Issues & Revisions
NO. DATE DESCRIPTION
2 10/04/23 REV 2

Project Name
WoodSpring Suites

Sheet Title
ROOF FRAMING PLAN
Sheet No.
S2.4
BRR Original printed on recycled paper

EXTERIOR
ELEVATIONS

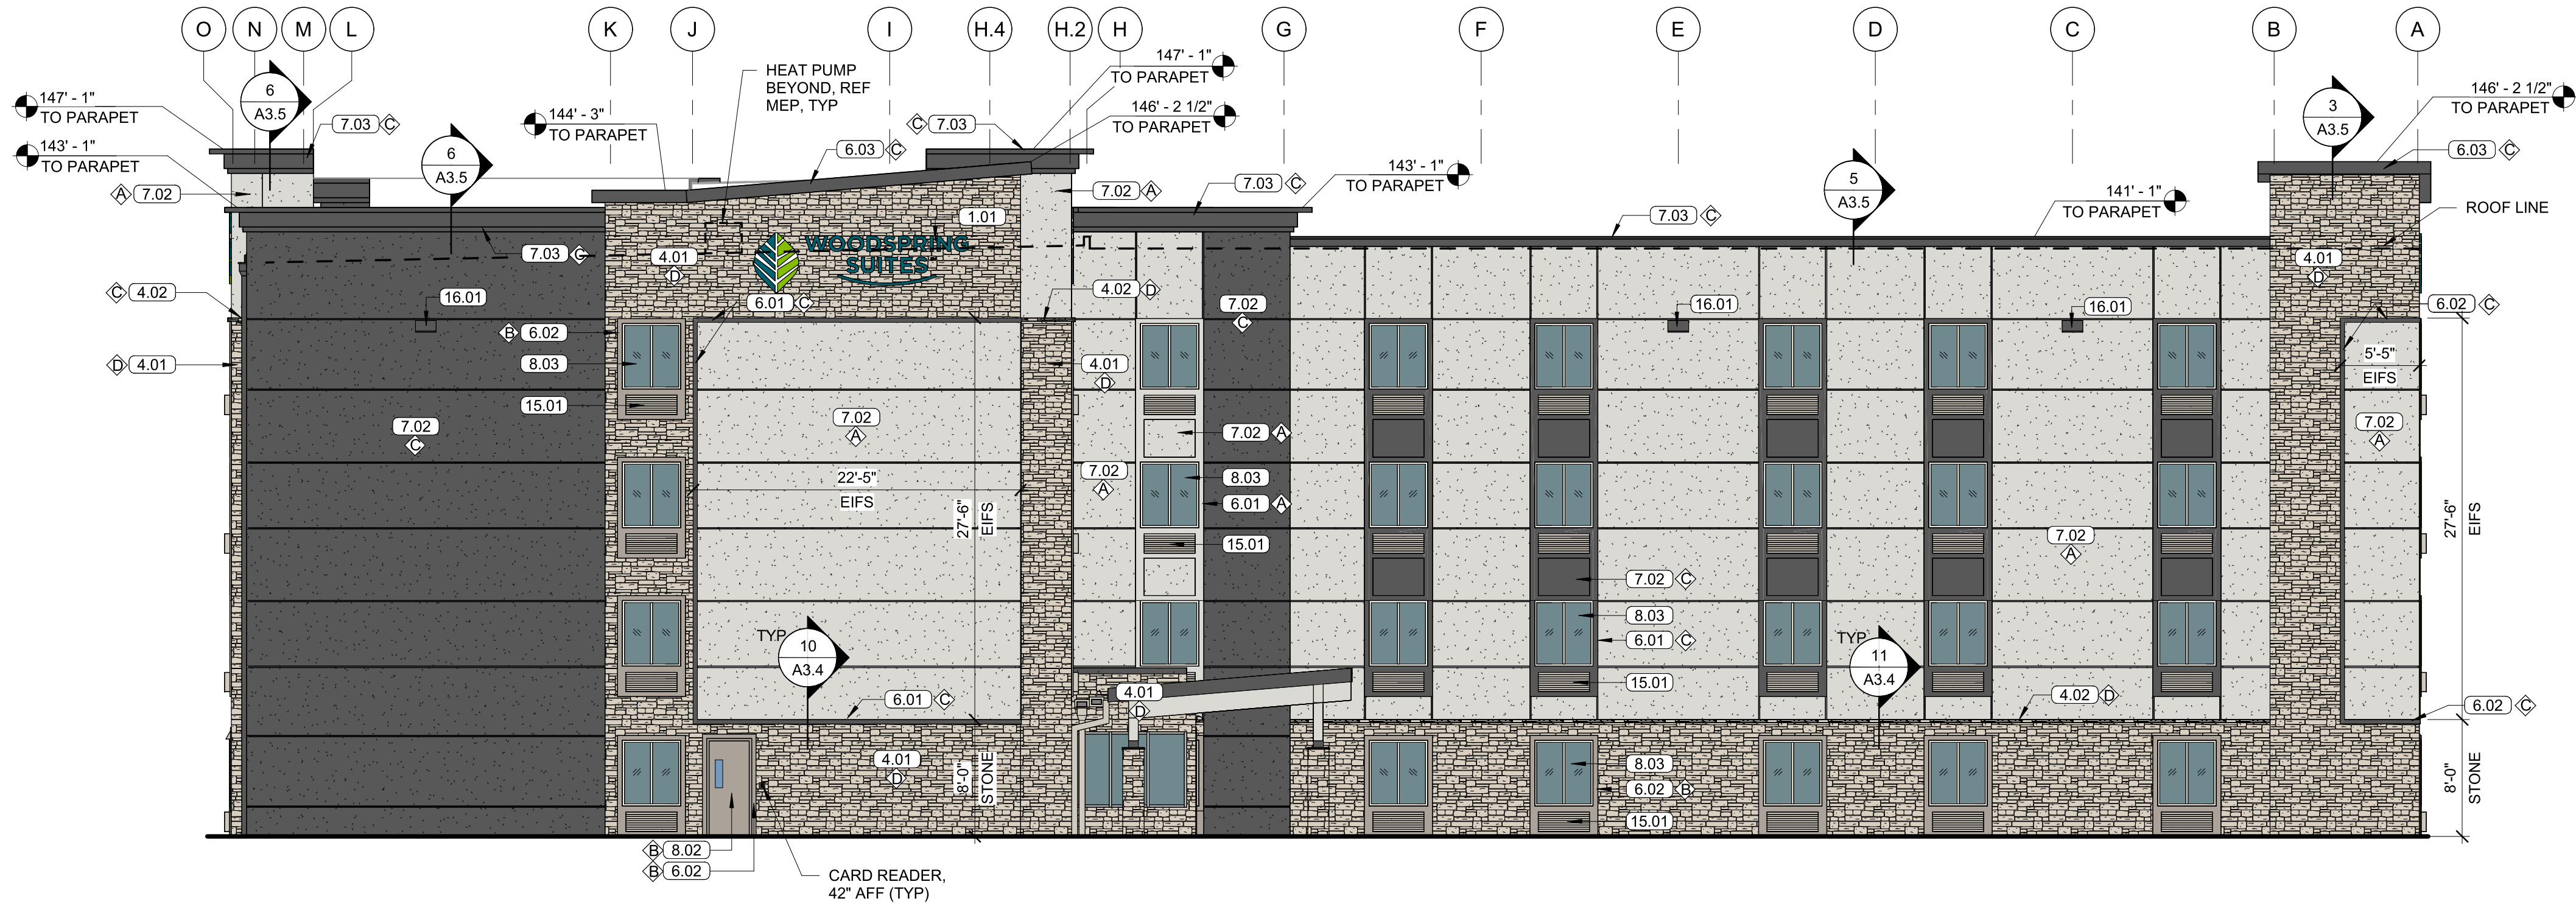
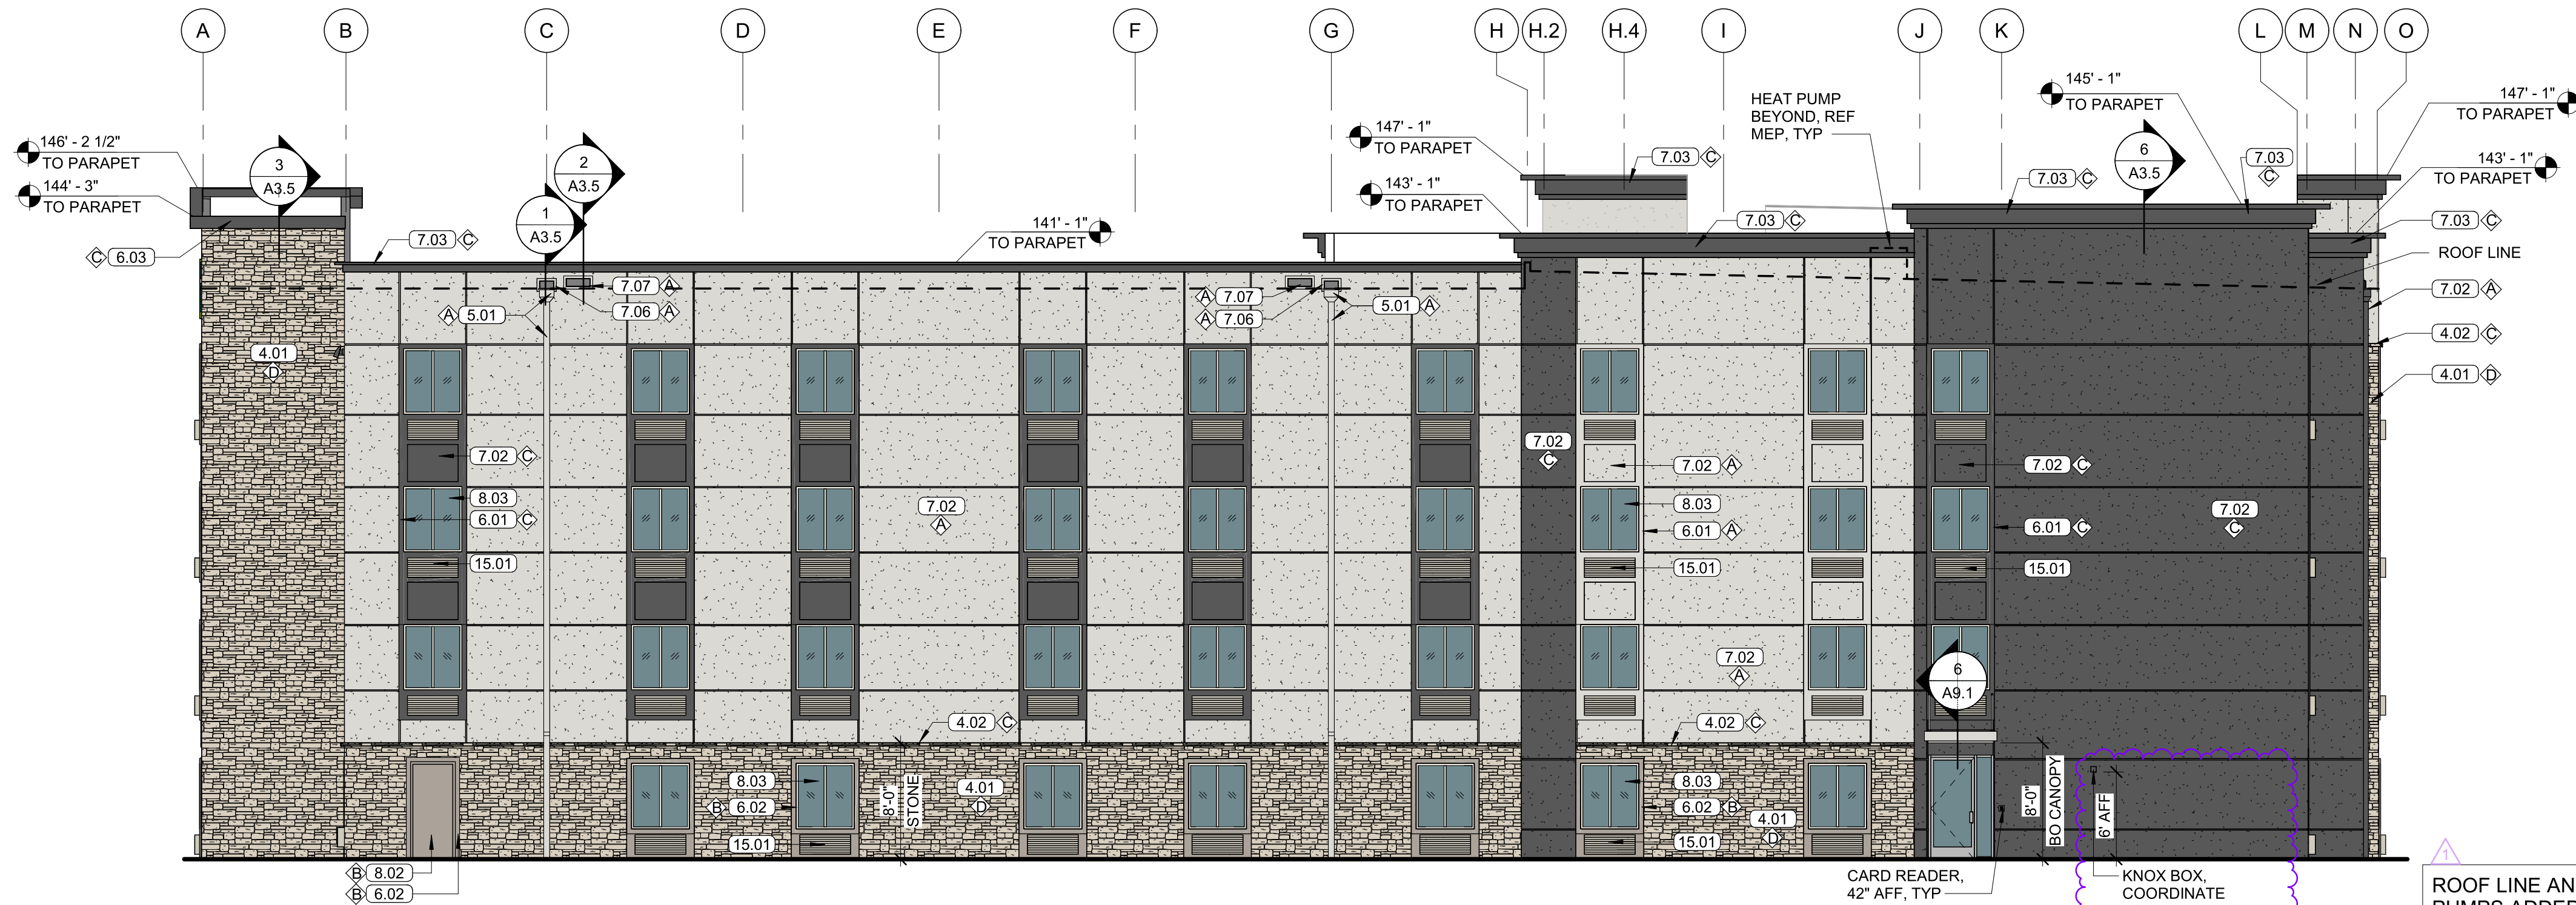
ROOF LINE AND HEAT PUMPS ADDED TO ELEVATIONS FOR THE FINAL DEVELOPMENT PLAN REVIEW REQUIREMENTS.
